Docket 8302

**STATE OF VERMONT PUBLIC
SERVICE BOARD**

PARTIAL MEMORANDUM OF UNDERSTANDING

Re: Chelsea Solar LLC 248 Petition (Docket No. 8302) – Petitioner’s Responses to the Vermont Department of Public Service’s First Discovery Requests

SUPPLEMENTAL SITE PLAN | Figure 1

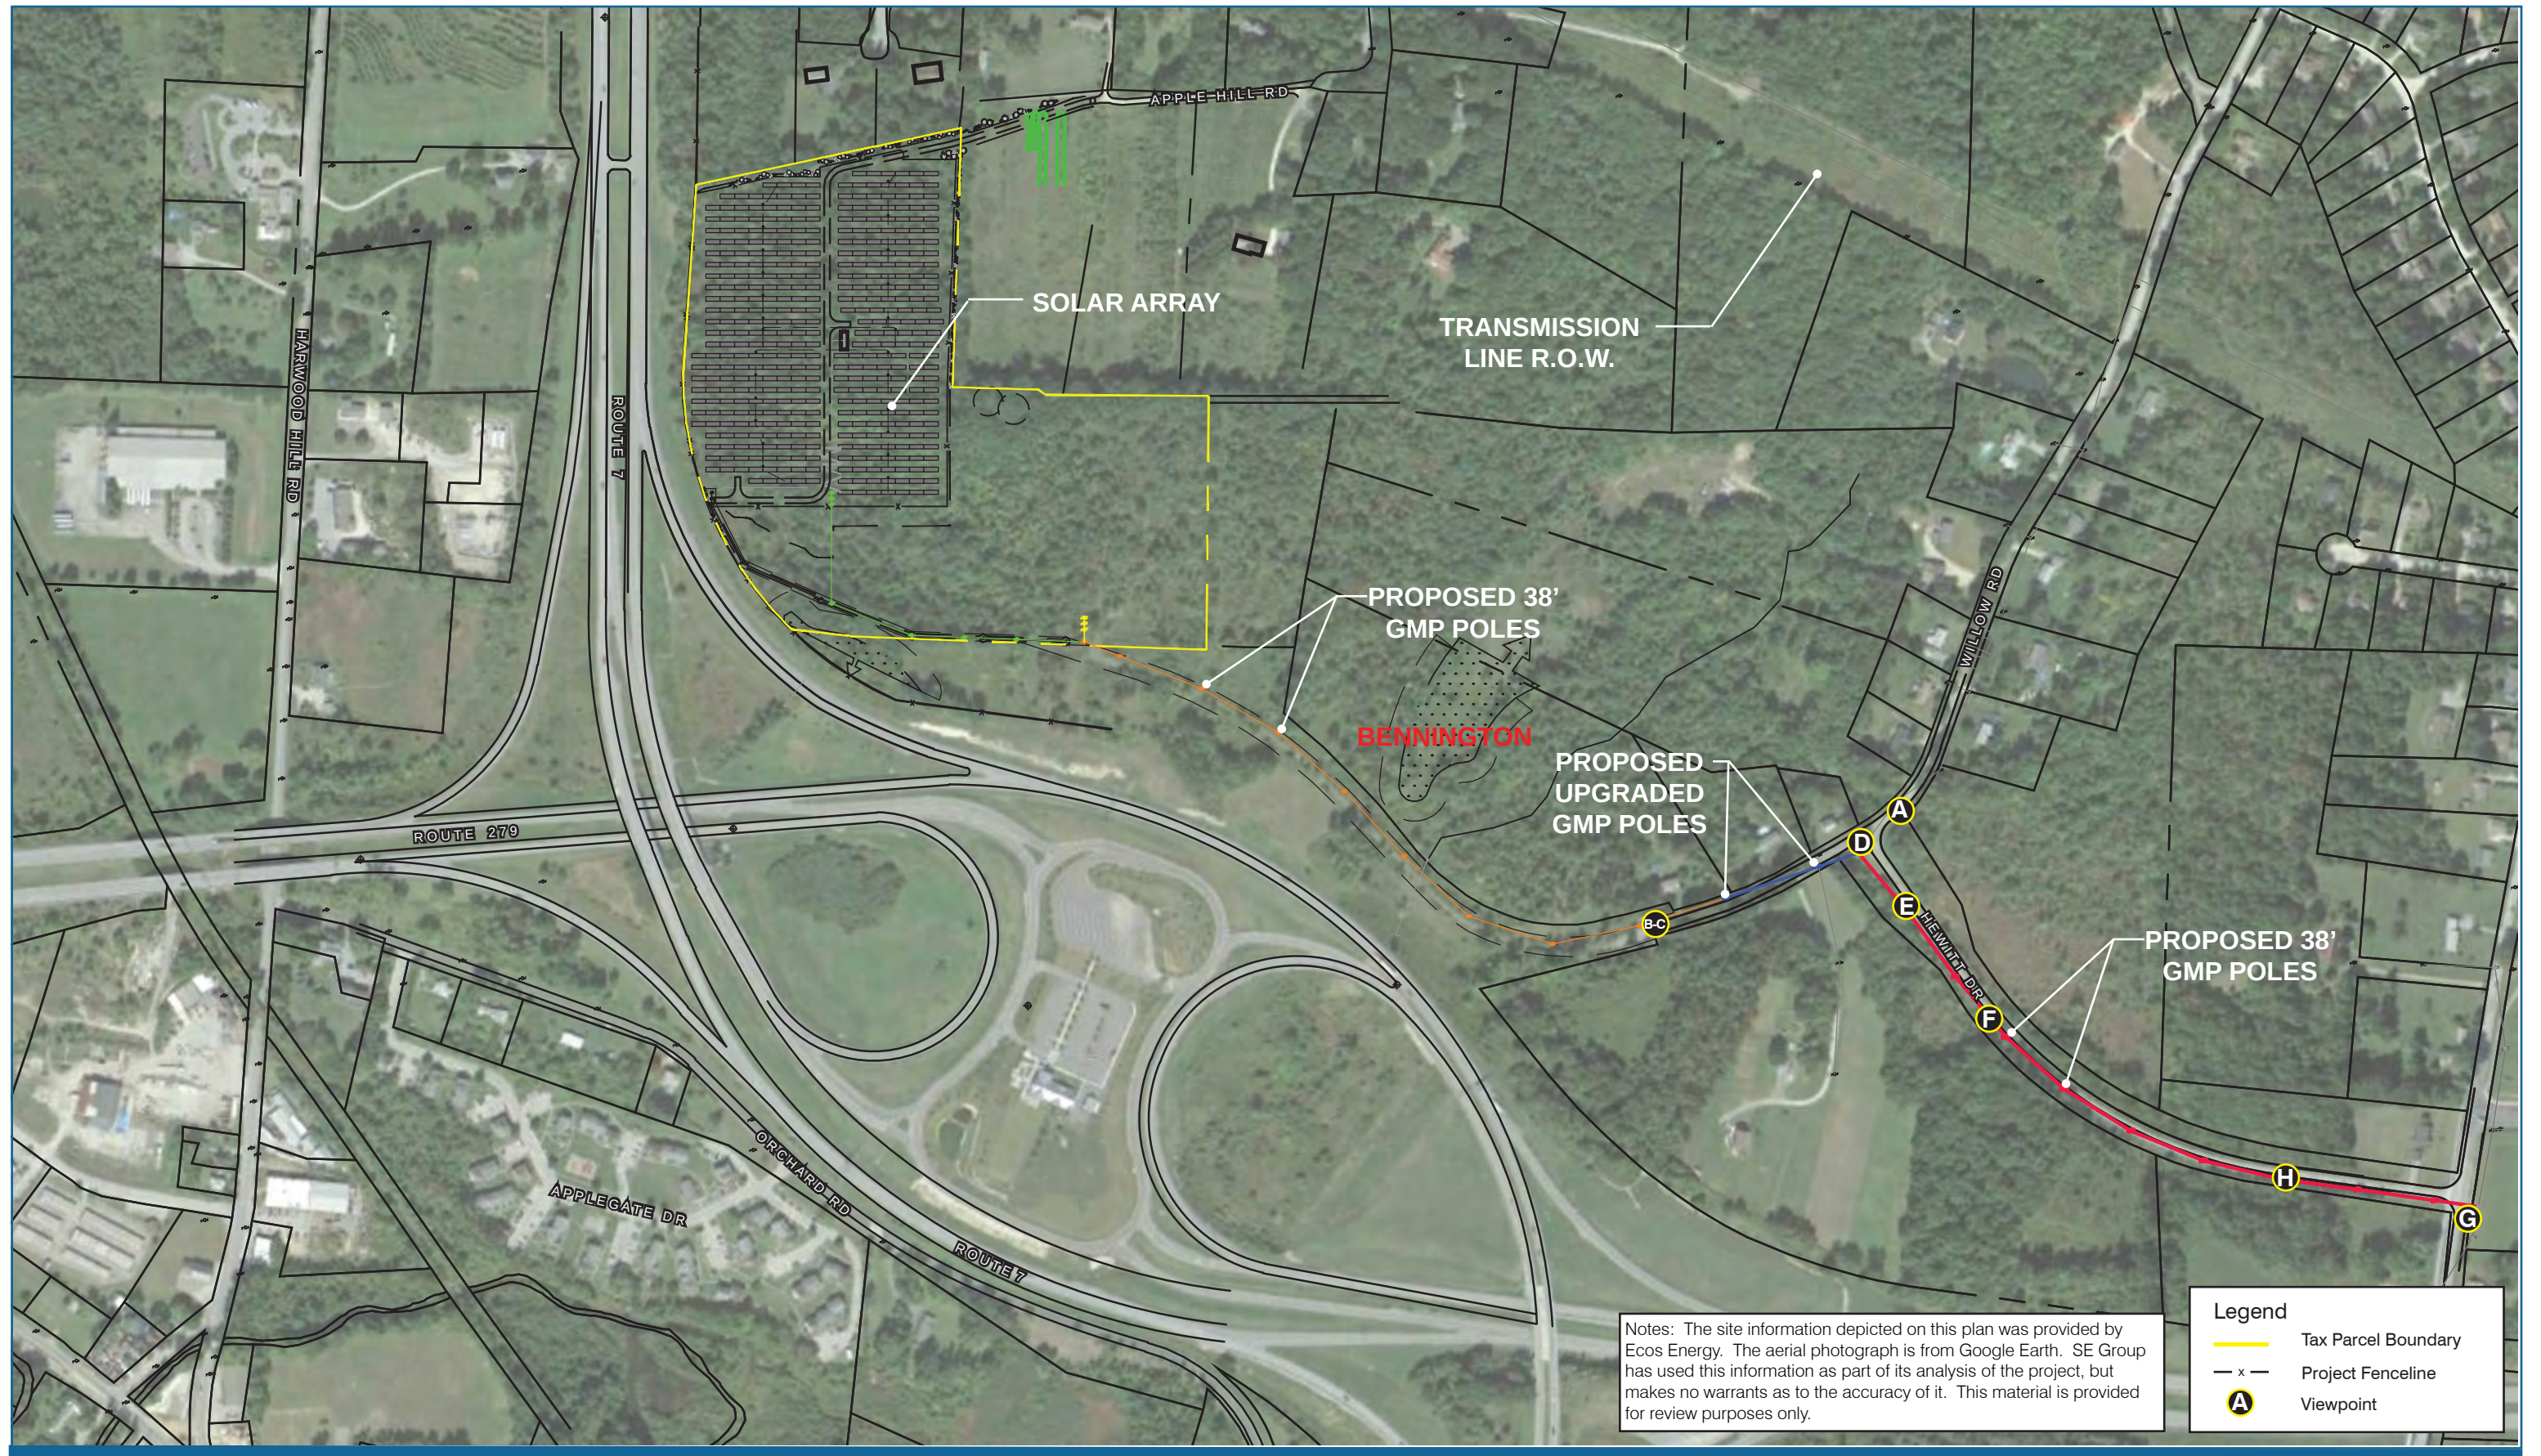
QUESTION 5: “Given the proposed new route of the line extension, depicted on attached Exhibit 1, coming into the project at its southern end, could the proposed plantings at the southwest corner of the project be supplemented, since this is the area where the project will be most visible from Route 7?”

QUESTION 6: “Please provide a visual impact assessment for the proposed new line extension to be located along Willow Road, Duffy Drive, and the new access road. Specifically address clearing that will occur along the roadside to accommodate the new or upgraded line. Please include the entire line extension in the assessment, whether on lands owned by the Petitioner or others.

RESPONSE 5: In response to this question, a new exhibit (attached hereto as Exhibit A) was prepared providing supplemental information on the location of the proposed line extension relative to the Project. Figure 1 of this information includes a supplemental site plan identifying three (3) components of this new extension. The segment in orange represents new poles along the access road (Willow Road) the Project. The segment in blue represents the upgrade of three existing poles to the new ones carrying the three-phase extension. The segment in red includes nine (9) new poles along Hewitt Drive. The final segment (in orange) includes nine (9) new poles and terminates at the interconnection point for the Project. All new poles will be wooden with cross-arms and be approximately 38 feet in height.

RESPONSE 6: As discussed in the response to question #5, supplemental exhibits were prepared to help evaluate aesthetic impact of the line extension as it relates to the overall Project. The supplemental site plan (Figure 1) identifies the route of the line extension which includes both new and upgraded components. The line, as proposed, extends along Hewitt Drive not Duffy Drive. Figure 1 identifies site photographs (See Figure 3 and 4) taken by SE Group highlighting the existing character of the route. The existing and proposed conditions for each of the three segments are described below:
